New Bridgewater Bridge Major Project – Representation on Initial Assessment Report

- Table 1 – Comments on Initial Assessment
- Table 1 – Suggested amendments to the 'conditions and restrictions' – general
- Table 3 – Suggested amendments to the 'conditions and restrictions' – Environmental Protection Agency
- Attachment A – Vibration Risk Assessment
- Attachment B – Assessment of potential for impacts on the heritage values of adjacent Local Historic Heritage Places
- Attachment C – Justification for the necessary demolition of 37 Black Snake Road
- Attachment D – Consolidated submission requirements
- Attachment E – Addendum to the Landscape and Visual Analysis

Figure A – Concept Design (2011)

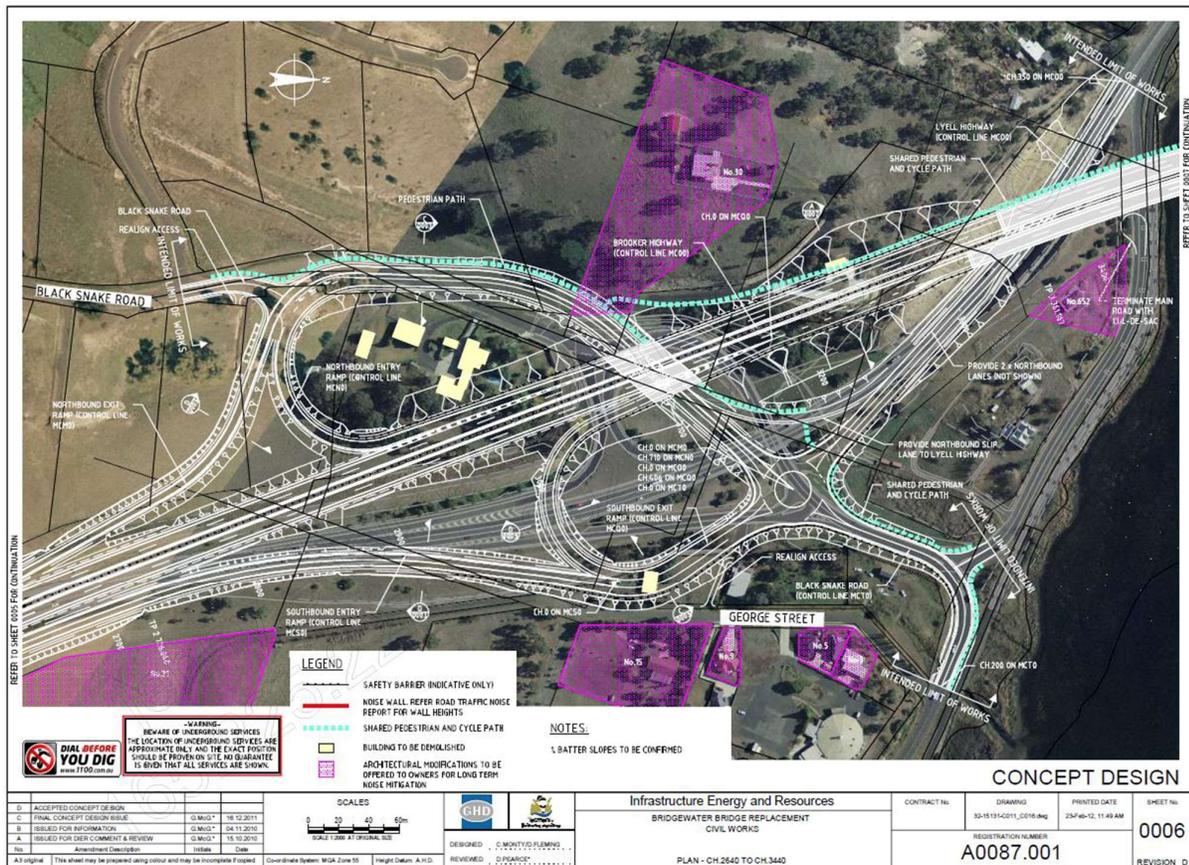
This design has a significantly longer bridge structure and more extensive road layout and therefore a higher, overall project cost.

Significantly, while impacts are minimised and do not require total demolition of all buildings on 37 Black Snake Road, the land parcel will become isolated and local access would not be possible with resultant occupancy of this property being questionable – particularly being an island within an interchange.

Figure B – Reference Design (2020)

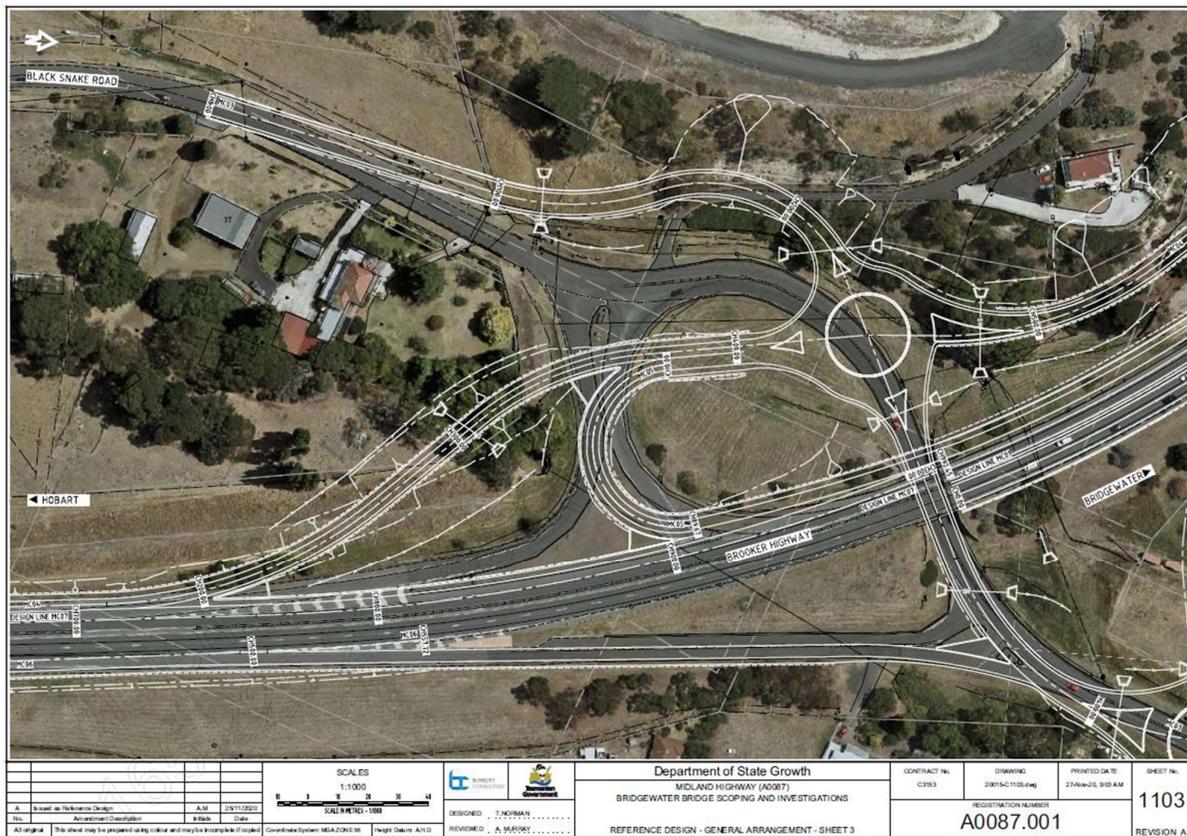
Significantly, this interchange design was minimised in size to reduce cost but made significant sacrifices to efficiency, with no “free flowing” connection between the Brooker and Lyell Highways.

As mentioned below, this was a key point of feedback from community and stakeholder consultation prior to the selection of the ‘chosen design’.
